GOVERNMENT OF THE DISTRICT OF COLUMBIA
DEPARTMENT OF TRANSPORTATION

MEMORANDUM

SUBJECT: BZA Case No. 18838 – 2737 Sherman Avenue, N.W. (Square 2885, Lot 100)

View of the project site and Sherman Avenue facing southbound

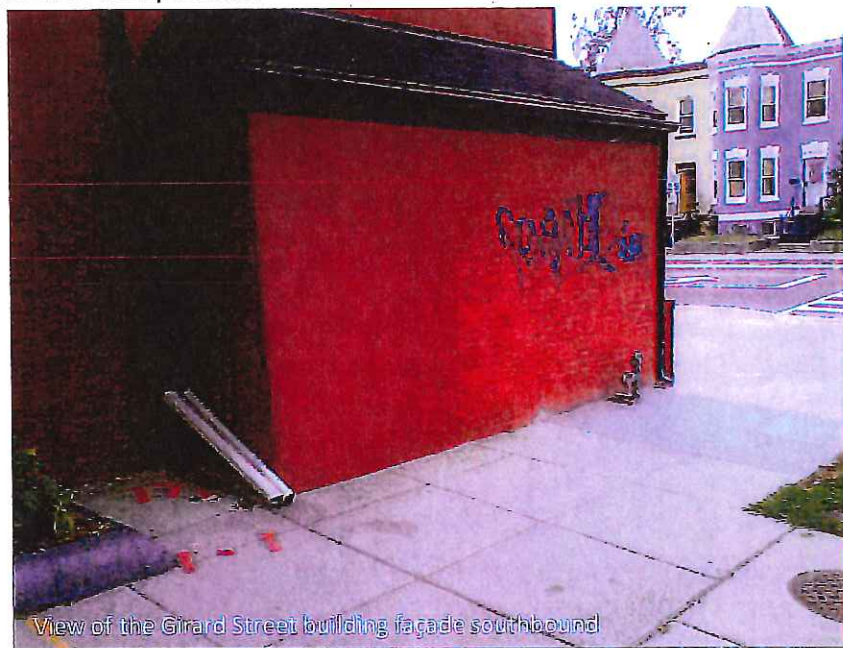
There are no loading zones in the vicinity of the site and the existing curb space along Sherman Avenue and Girard Street has RPP restricted parking. DDOT recommends the applicant develop a loading management plan (LMP) including information on delivery days, times, locations and restrictions and coordinate with DDOT on preferred loading locations in the vicinity, if applicable.
